McCULLOCH SERVICE BULLETIN

NO. 1597

MODEL Mini Mac 25, 30, and 35 DATE February 20, 1976

SUBJECT MDC 9 Carburetor, P/N 90440, MDC 11 Carburetor Kit, P/N 90918.

FIGURE 1

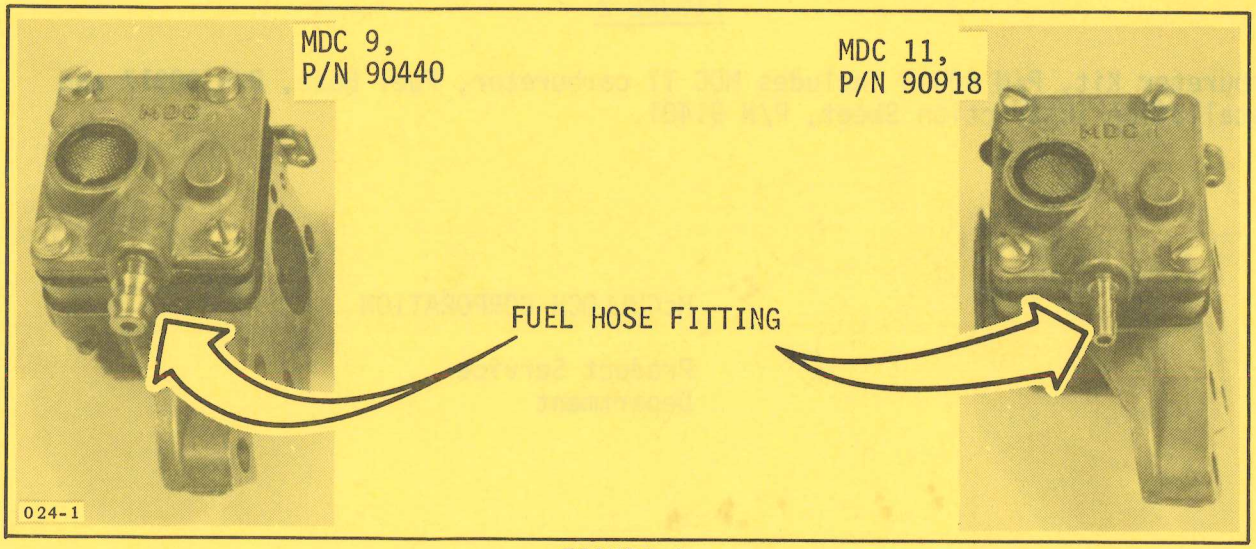
The major change between the MDC 9 and MDC 11 carburetors is the fuel hose fitting on the fuel pump cover and the fuel hose (Fig. 1).

The fuel hose fitting on the MDC 9 carburetor has a larger outside diameter and the fuel hose has a larger inside diameter than the fitting and hose on the MDC 11 carburetor.

TO PREVENT FUEL LEAKS, MAKE CERTAIN THE CORRECT FUEL HOSE IS USED WITH THE CORRECT CARBURETOR AND FUEL PUMP COVER.

FIGURE 2

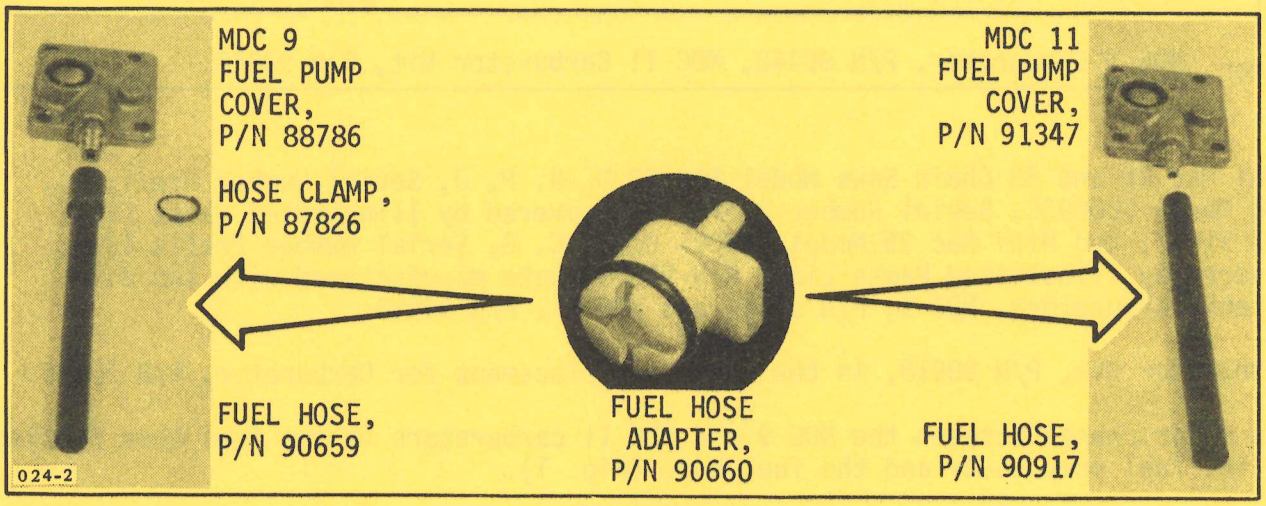
It is important that when fuel hoses and fuel pump covers are needed for service that the corresponding parts match (Fig. 2).

Carburetor Kit, P/N 90918 includes MDC 11 carburetor, Fuel Hose, P/N 90917 and installation Instruction Sheet, P/N 91401.
